DETAIL - D-J-213 - Block A - Green roof / Wall type WT7

DETAIL - D-J-214 - Block B1 North - Feature brickwork - Terrace head

LOND	ON NW5		1200	00.14
drawing TYPICAL JUNCTIONS - ROOFS & TERRACES Details 213 to 216  note: all dimensions to be checked to she be commencement of the work, if this drawing exceeds the quantities in any way the architects are to be informed before the work is commenced, for all other burgoses placer than planning application purposes do not scale, use dimensions, this drawing is posyright.			scale:	job no:
			1 :10 @ A1 1 : 20 @ A3	1952

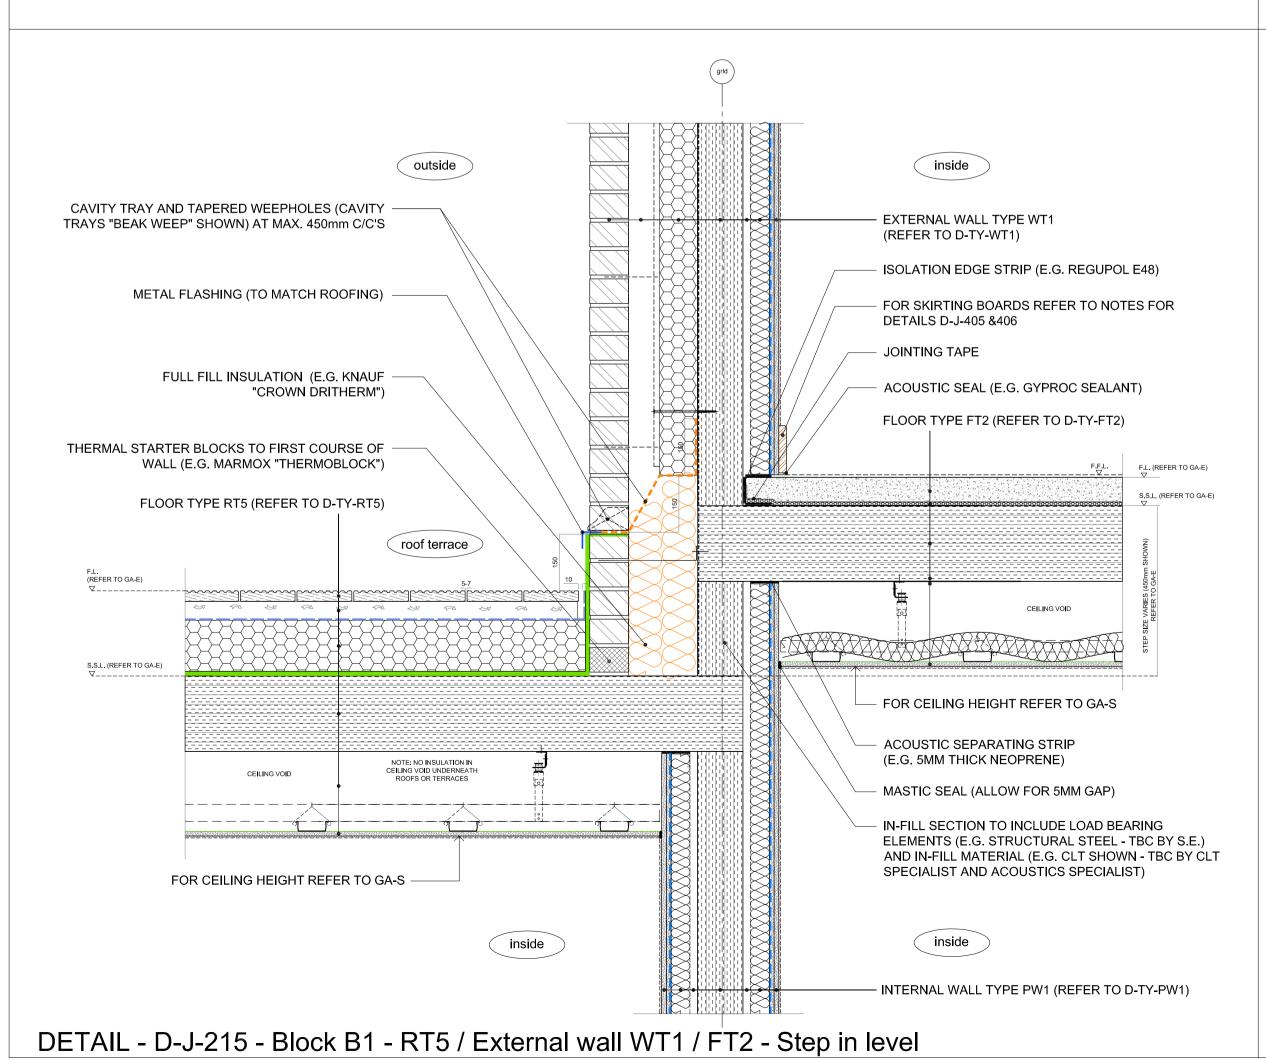
drawing no.	rev.
			D-J-213 to 216	as below
revisio	ns			
rev.	date	description	issued by	checked by
C1	27.08.14	Issued for construction	JPB	GW
C2	22.09.14	Parapet raised in height for D-J-213. Masonry restraints updated as Ancon designs.	JPB	GW
C3	21.10.14	Inner masonry leaf for D-J-214 changed from bricks to concrete blocks. Cavity trays revised for D-J-215 & 216.	JPB	GW
C4	23.10.14	Extent and pattern for FastClad revised for D-J-214 following consultation.	JPB	GW
C5	08.12.14	Updates in responce to KCA comments dated 14.11.14	JPB	GW
C6	16.01.15	Updates in responce to KCA comments dated 07.01.15	JPB	GW
C7	06.02.15	Updates in response to ECH minutes dated 22.01.15	GW	JPB
C8	16.02.15	Lintel added to detail D-J-214 as per Ancon advise in mark-up from August 2014	JPB	JD
C9	17.02.15	Updates in response to Rheinzink comments dated 04.02.15	JPB	DW\
C10	23.02.15	Updates in response to KCA comments 18.02.15	GB	JPB
